**DEPARTMENT OF THE ARMY**  
**JACKSONVILLE DISTRICT CORPS OF ENGINEERS**  
**COCOA REGULATORY OFFICE**  
**400 HIGH POINT DRIVE, SUITE 600**  
**COCOA, FLORIDA 32926**

Regulatory Division  
North Permits Section  
SAJ-2006-8043 (MOD-AWP)  
**MODIFICATION 1**

This letter is in reference to your request for a modification of Department of the Army permit SAJ-2006-8043 (IP-AWP) issued to FDOT, District 2 for the re-design of the Interstate 295/Collins Road interchange.

By copy of this letter the U.S. Army Corps of Engineers is granting your request for a modification of the existing design to allow for an additional 0.68 acre of impacts to ponds 4 and 7.

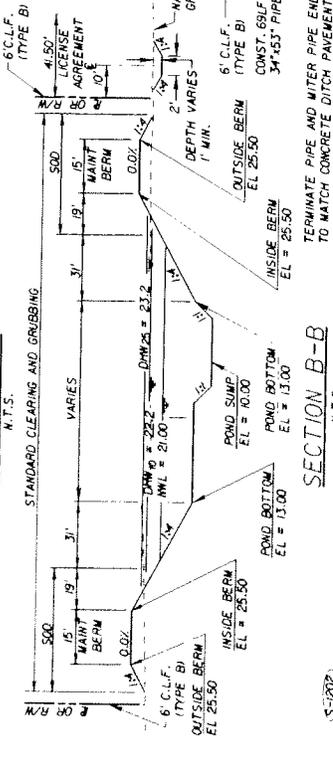
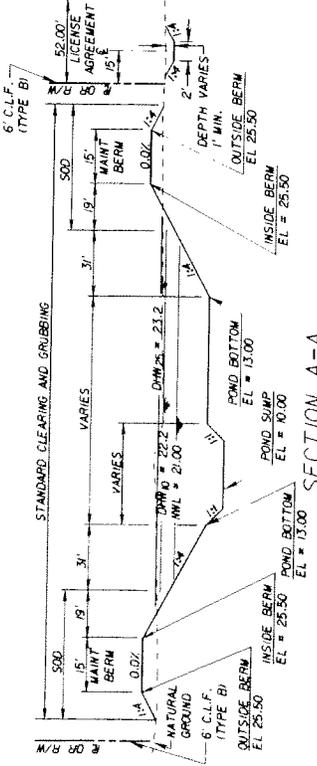
At Pond 7, the proposed pond is shifted southward from the previously permitted location. A small bypass ditch is also proposed along the western and northern sides of the pond to protect the berm integrity. These alterations will impact 3.16 acres of highly disturbed forested wetlands (WL-SB1) - an increase of 0.62 acres from what was previously permitted. Historically WL-SB1 was characterized by seasonally inundated/saturated pine flatwoods. Presently it consists of a canopy of predominantly laurel oak and water oak with a groundcover of chain fern. The current owner periodically mows the site during dry periods. Past silvicultural practices as well as road and drainage improvements have impacted the historic wetland hydrology. Drainage to the Ortega River system is via ditches with culverts.
